Concerning COP for UN-R QRTV

JASIC

28. October 2014

Range of vehicle noise and background noise in Japan

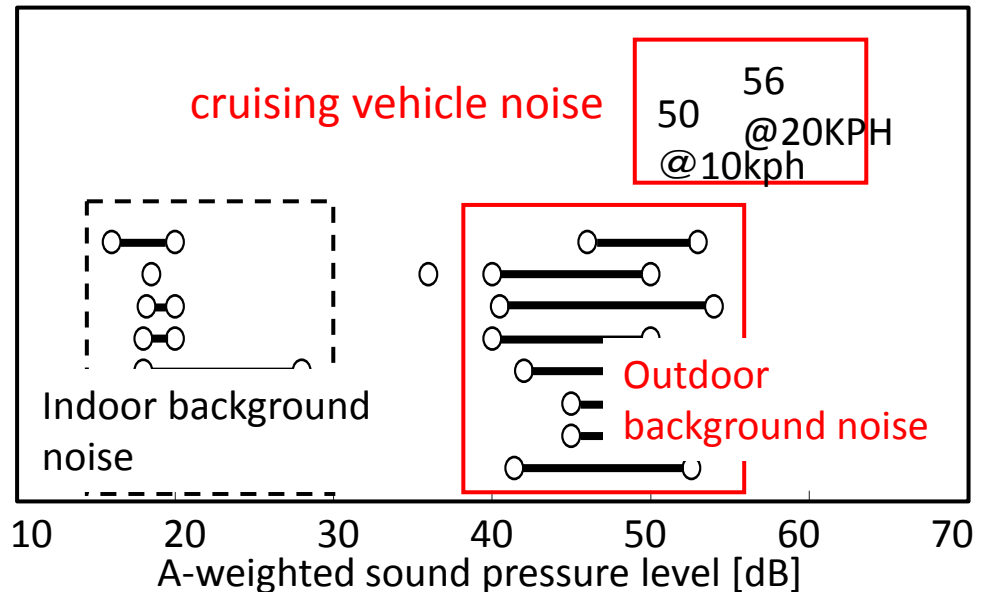
- Practically, outdoor test cannot be carried out due to background noise.
- In type approval test, indoor test can be useful.
- COP test is carried out in factories. If the test is required for QRTV, it cannot be done in factory. Because background noise is high and they don't have indoor test facility.
